### **Planning and Zoning Board**

### Meeting Minutes

Mesa City Council Chambers - Upper Level, 20 East Main Street Date: November 12, 2025 Time: 4:00 p.m.

#### Work Session June 10, 2025

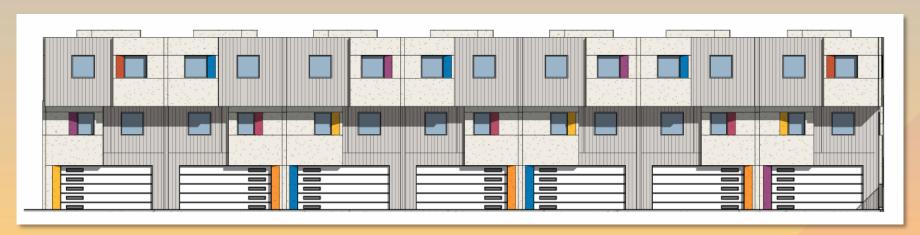
- •Tiered garden concept is nice, provide larger area Larger planters provided
- •Increase the area of the amenity space Due to site constraints, we can't enlarge the space, but a bonus area was added North of bldg 1

- •Too tight between the buildings Enlarging the drive aisle will reduce the amount of space where the pedestrian walkway is. To maintain a comfortable pedestrian experience, the drive aisle will remain as shown.

- •Cubelike; not enough movement See revised elevations
- Needs additional movement on the non-garage side See revised elevations
- •Wall articulation 2nd story bump out 12" instead of 6" Doing so would encroach on drive aisle width

- •Vertical siding entries should be at the 25% for the entry elevation See revised elevations
- •Long-term maintenance of colors?
- •Remove colors from top hats See revised elevations

- •Paint SES to match adjacent walls See revised site wall plan.
- •Planters are tight See revised amenity area
- •Swap the sidewalks at the perimeter for the planters so that there is more space for landscaping Sidewalks at perimeter are needed to access unit entries.

- •Oaks drop sap (messy), also Oaks near the parking areas is problematic See landscape
- Taller trees needed See landscape
